PLAN-018201

Proposal: Application for approval of matters reserved under outline permission APP/14/00547 (layout, scale, appearance and landscape) for development comprising 125 residential dwellings, associated amenity spaces, access, garages, parking, internal roads, pathways, sustainable urban drainage and associated landscaping in addition to the provision of a water retention area.

Site: Land west of Horndean Road and south of Southleigh Road, PO10 7PU.
APP/17/00358

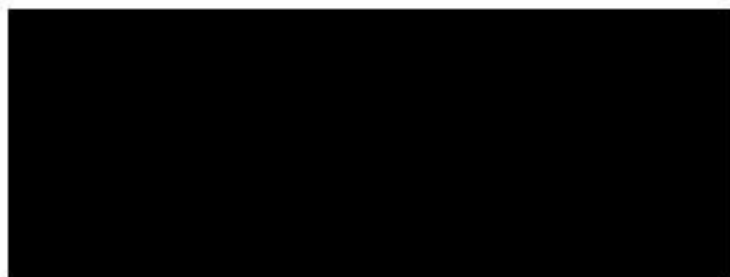
The construction of tanked permeable paving over or within 5 meters of public or adoptable sewers is not acceptable to Southern Water.

Surface water attenuation tanks should be located no closer than 5 meters from public or adoptable sewers.

The design of surface water drainage should ensure that no overflow from ponds is to enter public or adoptable sewers network.

Please note that on-line surface water storage is not adoptable by Southern Water.

The diversion of public surface water sewer has to be agreed and approved by Southern Water under Section 185 of the Water Industry Act for the final drainage layout to be agreed. Southern Water would require clarification on the construction details of fencing and walls within 3 meters of the public foul sewer. The above matters should be agreed under discharge of protection of public sewers condition.
